**VALUE ENGINEERING STUDY
FOR**

**UPGRADE
PUMP STATIONS 2 AND 3
JEFFERSON PARISH, LA**

DOD SERVICE: USACE
CONTROL NO: CELMN-VE-98-01
VALUE ENGINEERING OFFICER: Frank Vicidomina

The Value Engineering Study was conducted in the New Orleans' District Office during the week of 6-10 October 1997. The study was based on the Concept (50%) Design Submission Reports, dated October 1997.

DRAWING NO. 1

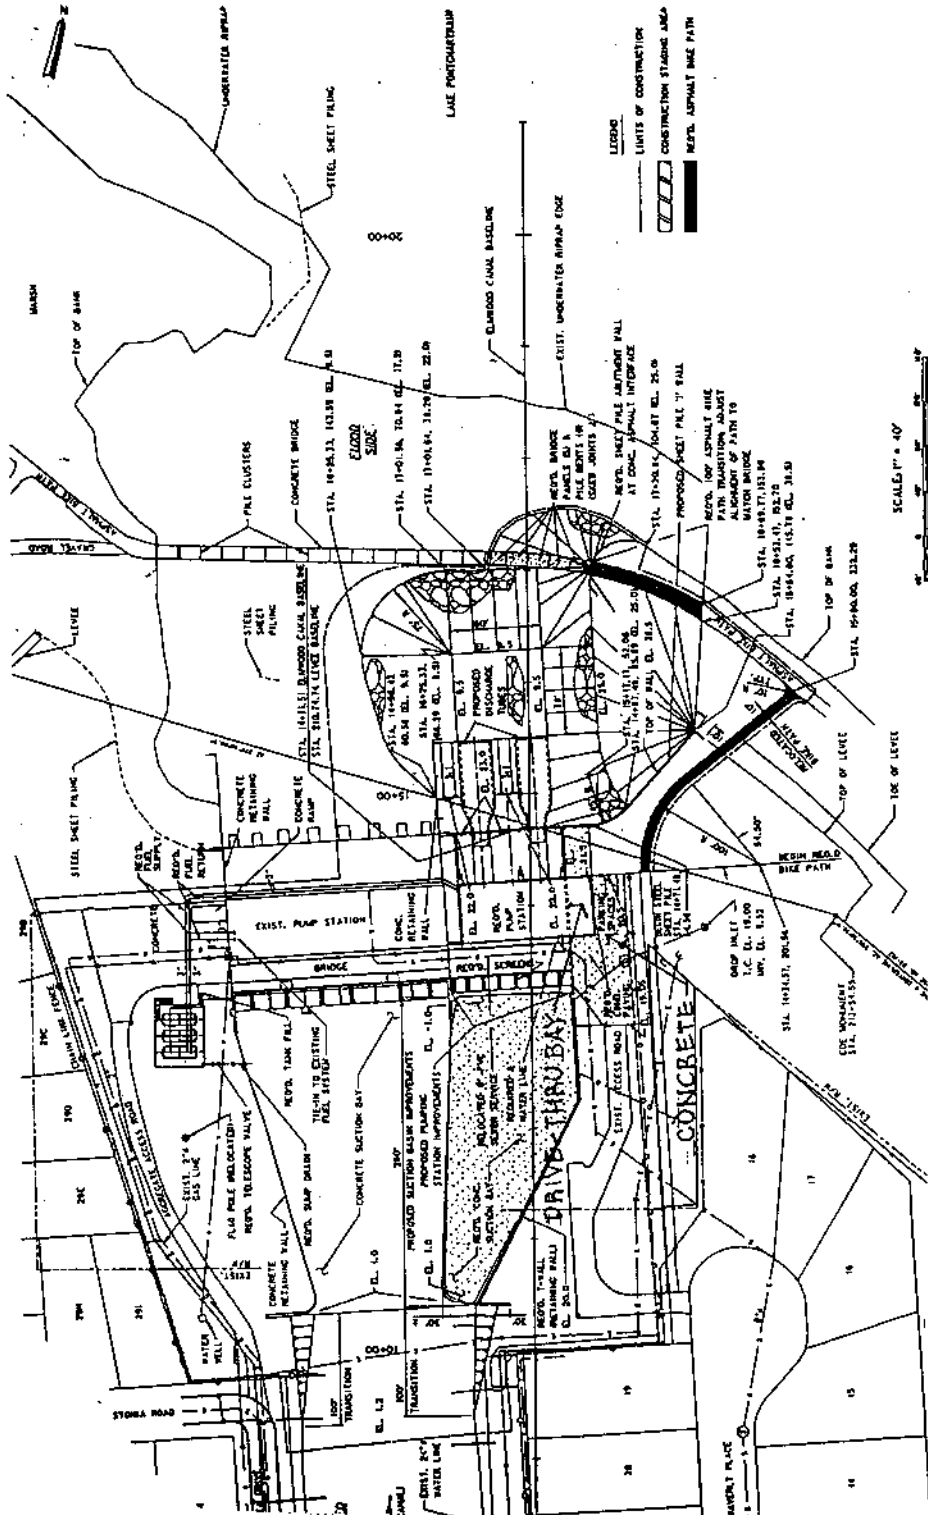
Drawing No. 1 shows concrete paving for the area immediately adjacent to the new building addition. The east end of the addition encloses a drive-thru/loading dock at grade level (see Drawing No. 2).

Except for the enclosed drive-thru/loading dock, substitute a bituminous paving system for the concrete paving.

1. Concrete paving does not appear to be necessary or justified in this location, particularly since the corresponding adjacent area for Pump Station No. 2 has been requested by the User to be constructed of bituminous surface material (see Drawing No. 3).
2. Reduces construction costs.

DRAWING NO. 1

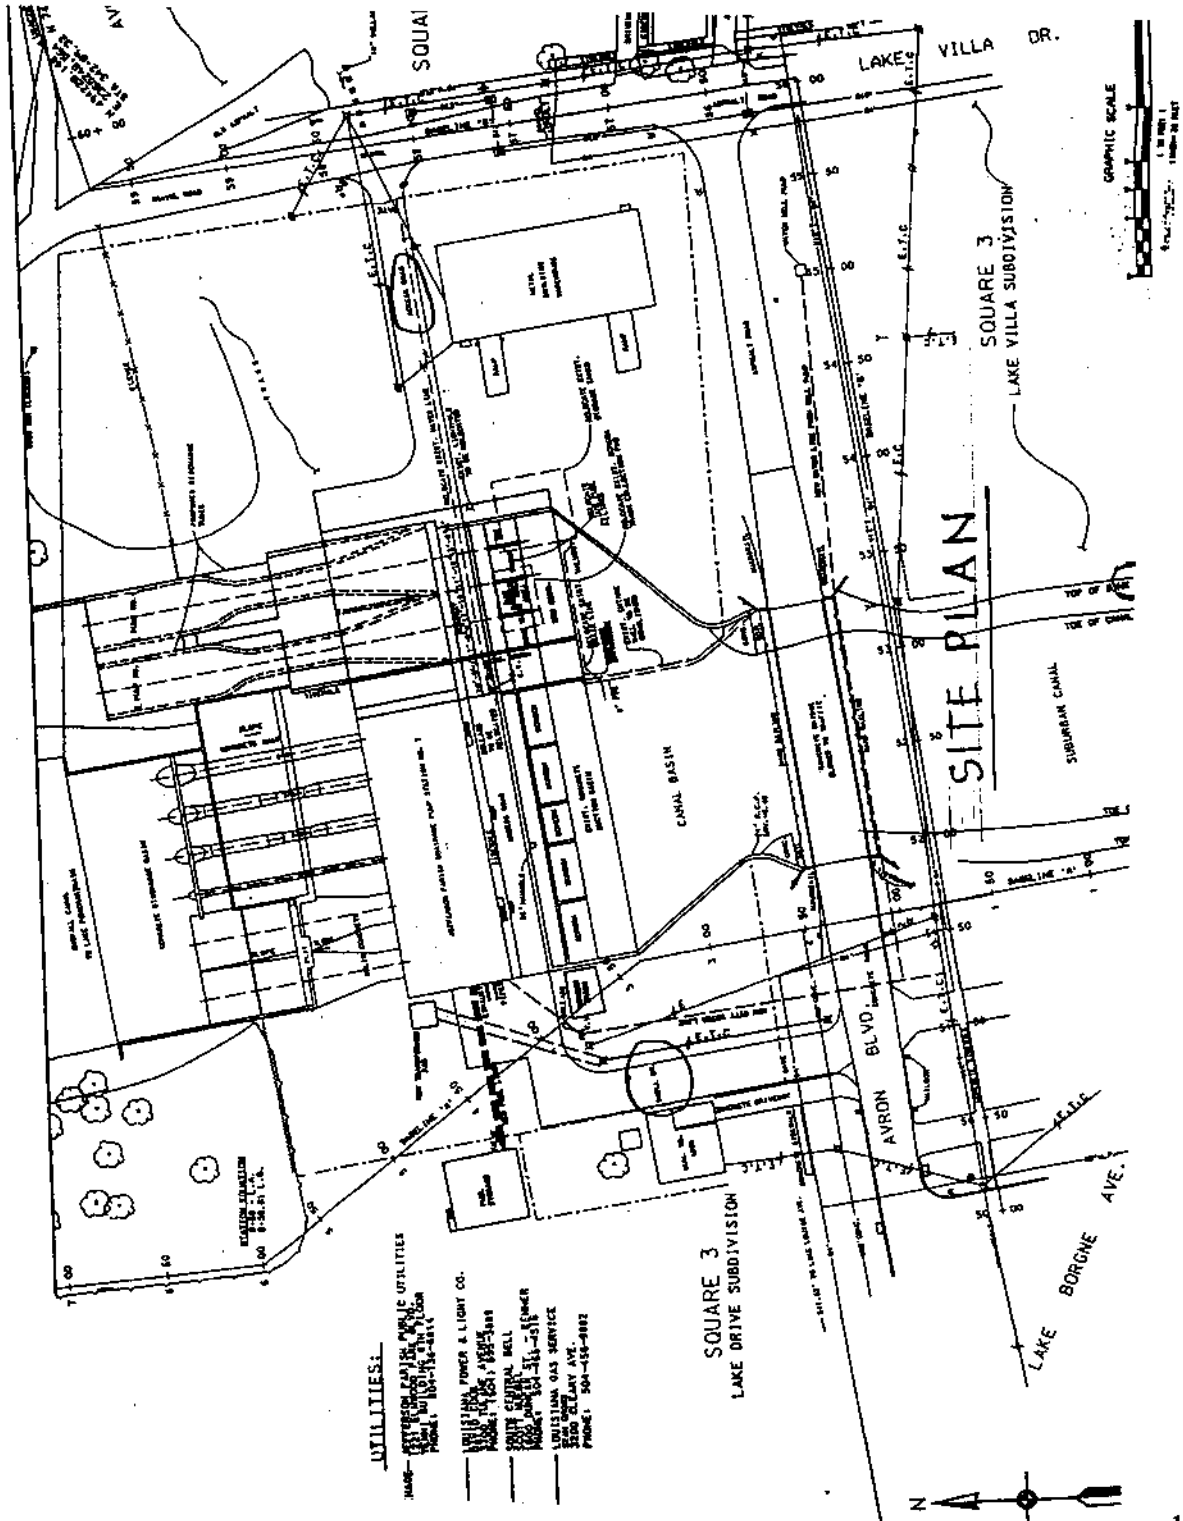
Drawing No. 1 shows a new access road from Lake Villa Drive to the new building addition, and existing Shell Drive leading from Avron Boulevard to the existing Pump Station. The latter road is gravel, and the new access road is specified to be crushed limestone.

Recommend bituminous paving system be substituted for the gravel and crushed limestone roads.

1. Bituminous paving will not create the numerous maintenance problems experienced by the Users with the existing gravel road and the specified crushed limestone.
2. The User requested bituminous paving as a quality improvement.

DRAWING NO. 1

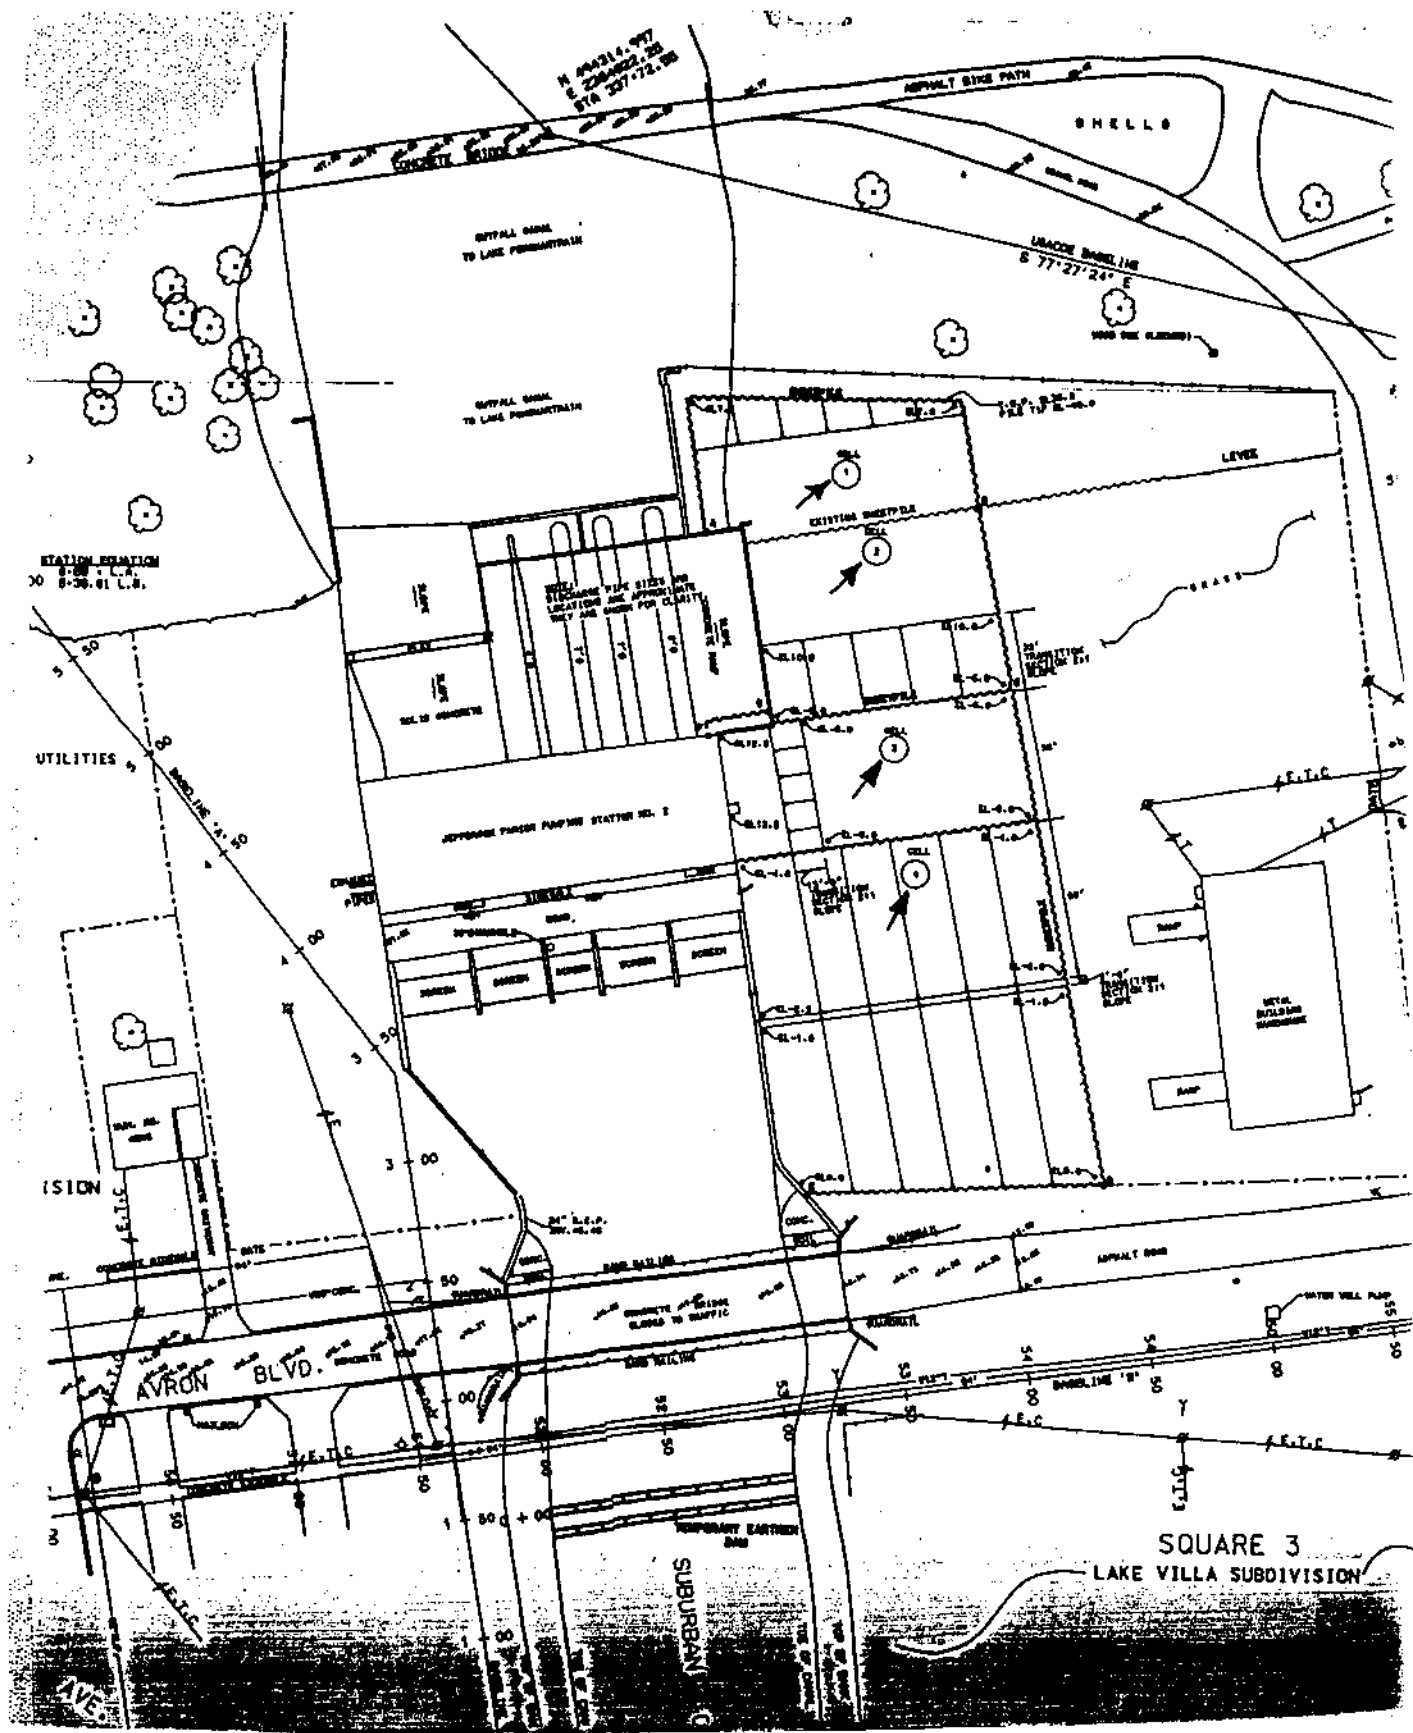
The current design creates four cofferdam cells on the east side of the existing pump station. Cells 1 and 2 are for the excavation of material to construct the discharge tubes. Cell 3 is for excavation of the pump station building and Cell 4 is for the intake suction basin (see Drawing No. 1).

Construct two cells. The first cell (Cell 1) will be north of the existing sheet pile floodwall. This cell is the same as the current Cell 1. The second cell (Cell 2) is a combination of Cells, 2, 3, and 4 from the existing design. However, these two new cells are reduced in size from the area in the current design. It is 15' closer to the existing facility and parallels the intake suction basin on a diagonal to the Avron bridge abutment (see Drawing No. 2).

This proposal eliminates the sheetpile wall between Cells 2 and 3 and between Cells 3 and 4 because there is only 2' of difference in the depth of their excavations. This shallow of a depth difference can be handled by cutting back the slope at much less expense than placing sheetpiling. The southern end of the construction is changed to a diagonal paralleling the design channel wall which reduces amount of sheetpiling and excavation. Each of the changes is feasible and will result in cost savings during construction. They will also make it easier for the contractor to move around in one large cell rather than across three smaller ones.

DRAWING NO. 1 -- Original Design

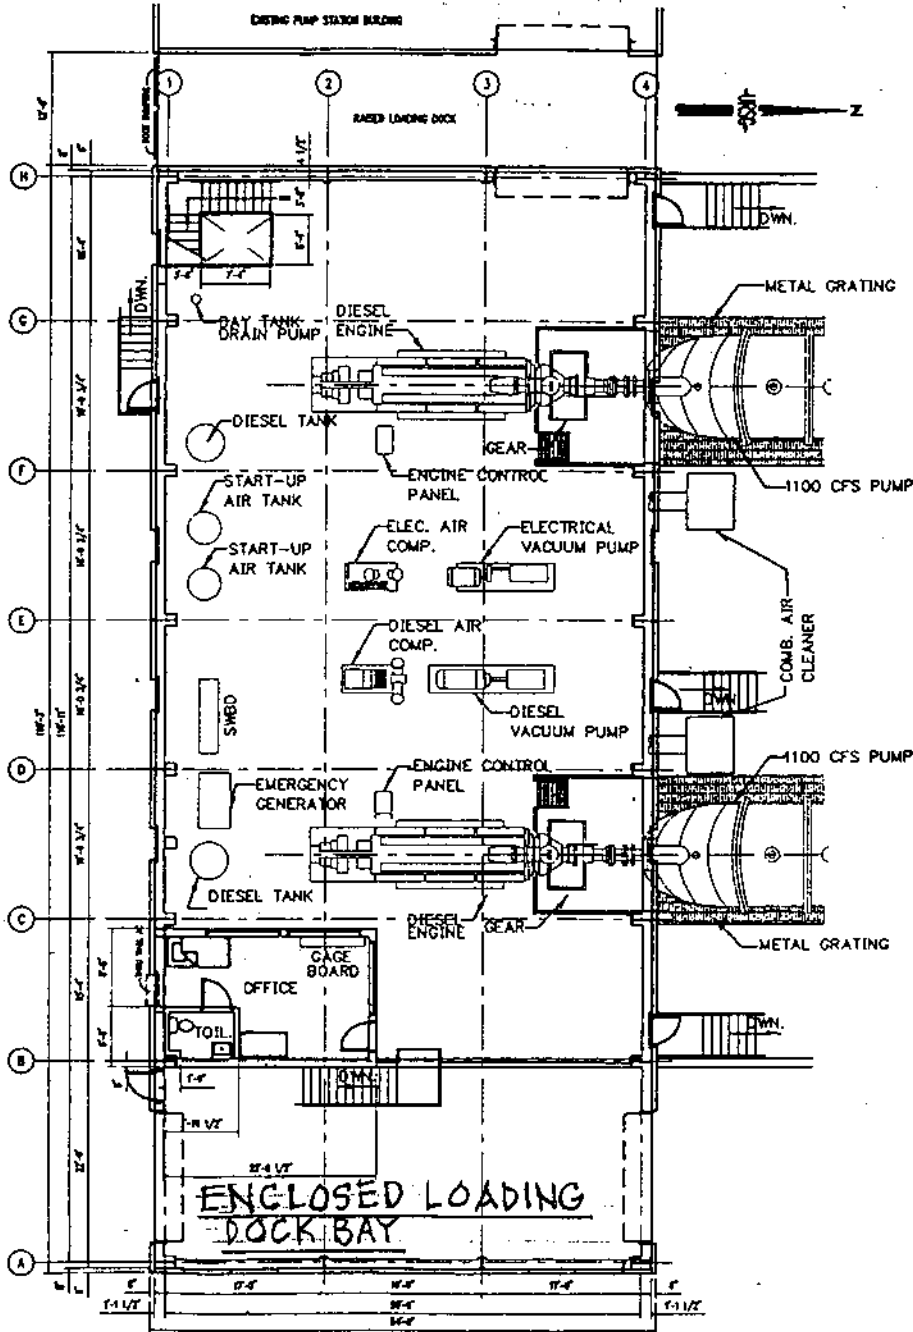
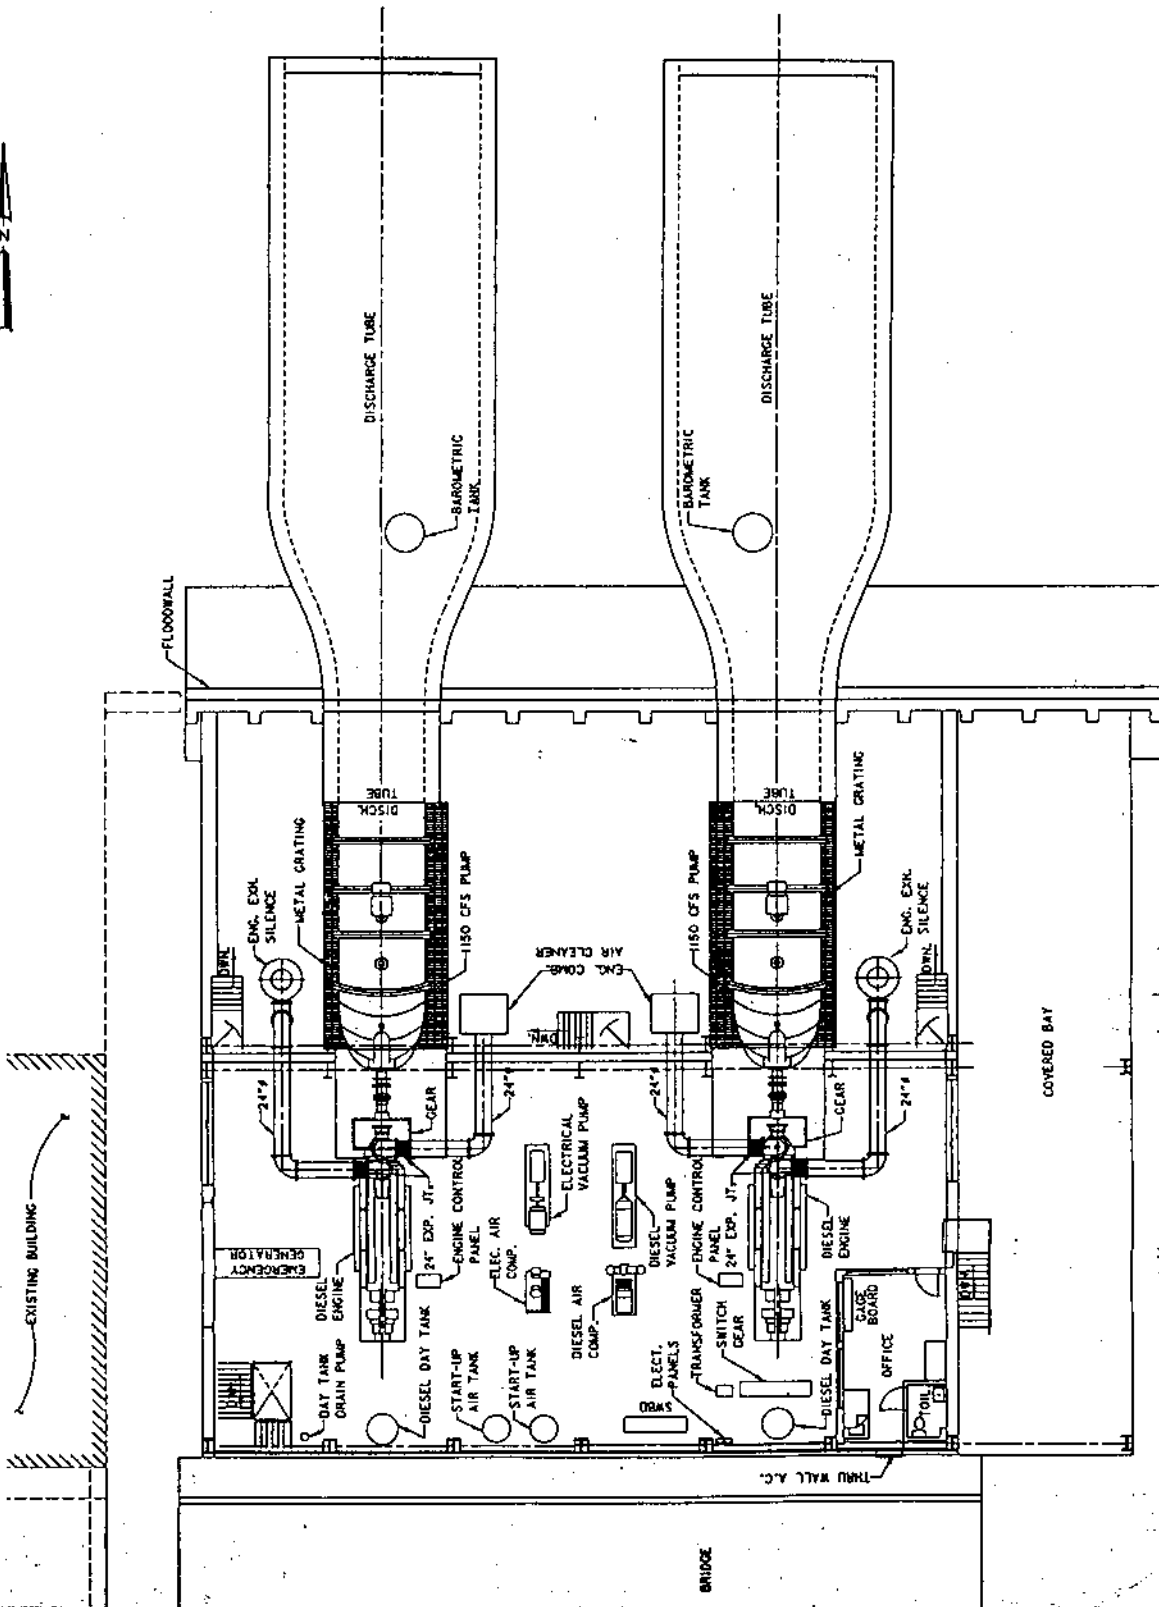
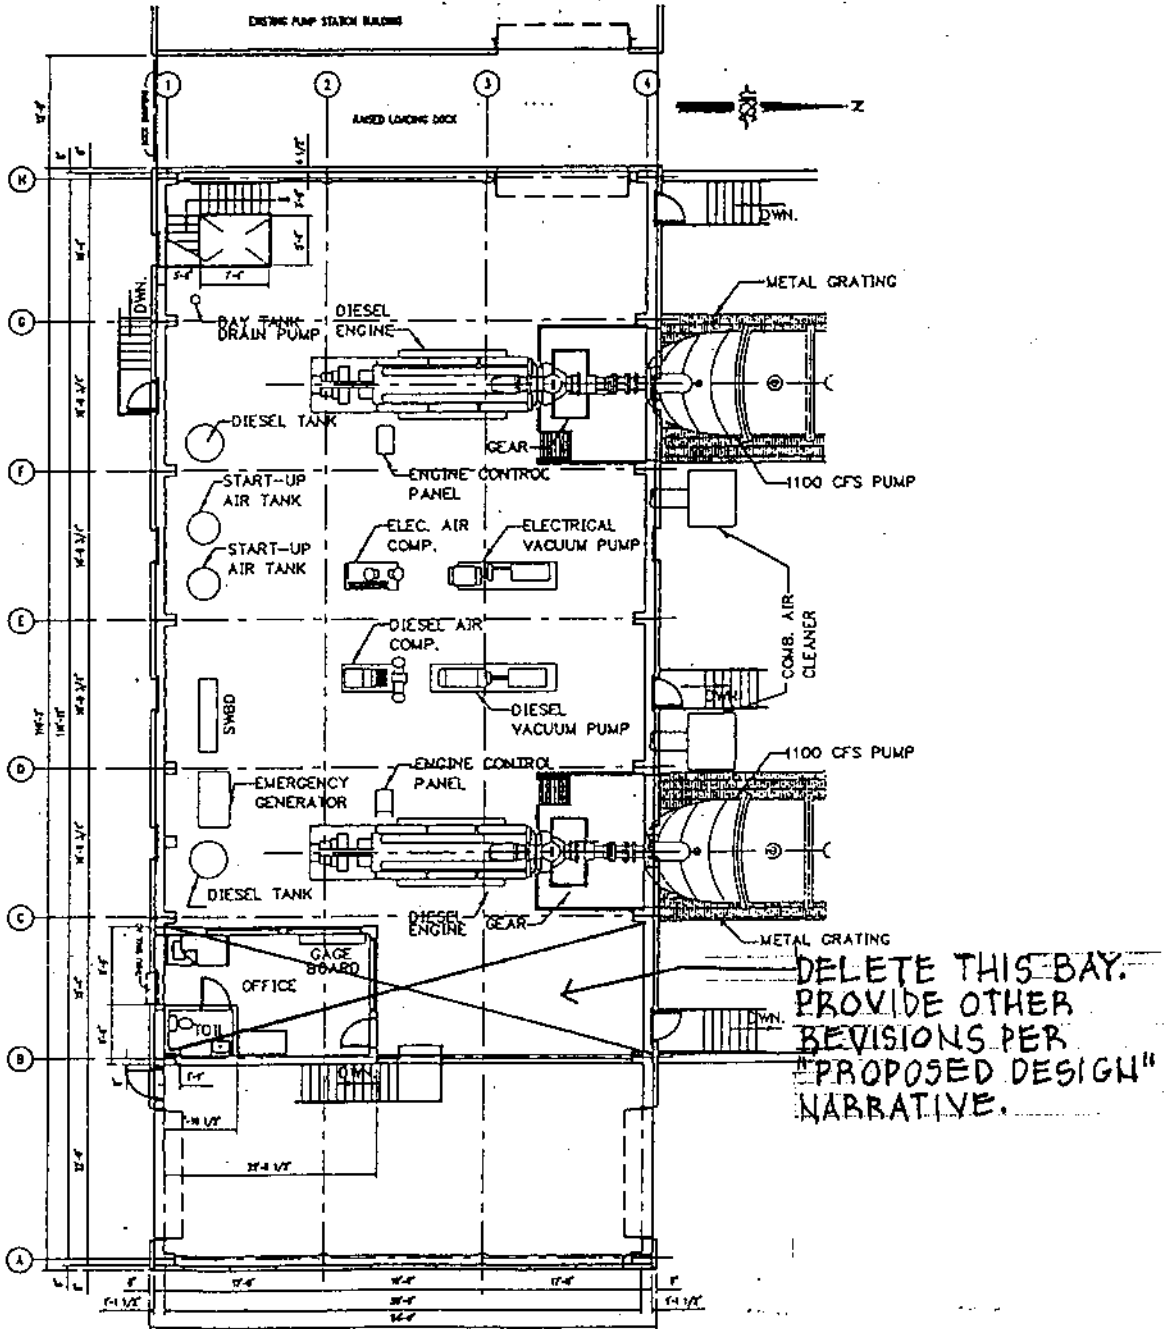
The current architectural floor plan shows an office located between Column Lines B and C. Adjacent to it is an enclosed drive-thru/loading dock bay for maintenance vehicles between Column Lines A and B. The mechanical floor plan reveals engine exhaust (from the diesel engine nearest to the office) penetrating the building's north wall. The mechanical floor plan also shows two combustion air cleaners penetrating the building's north wall. (See Drawing Nos. 1 and 2.)

1. Delete the structural bay containing the office. Relocate the adjacent enclosed drive-thru/ loading dock bay to the deleted office bay location.
2. Relocate both engine combustion air cleaners to the building's interior, making both air cleaners engine-mounted (per those in the existing building).
3. Relocate the engine exhaust silencer and its piping to the west (vice the east) side of the easternmost pump.

- 1 and 3 Another office with its own gage board is not necessary. That in the existing building appears sufficient. Also, the engine exhaust silencer can be relocated to another bay.
2. Those within the current building which are engine-mounted are apparently operating adequately.
- 1 and 2 Reduces construction costs.
